# ADA Curb Ramp New Construction Inspection Form (Perpendicular)

NW 292 st

23885.56

NW Keenon st

## PERPENDICULAR RAMP (PR)

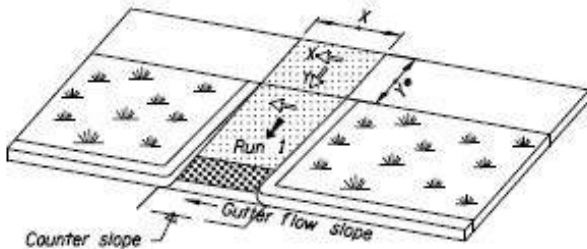
1RR ICRR IITD not full width
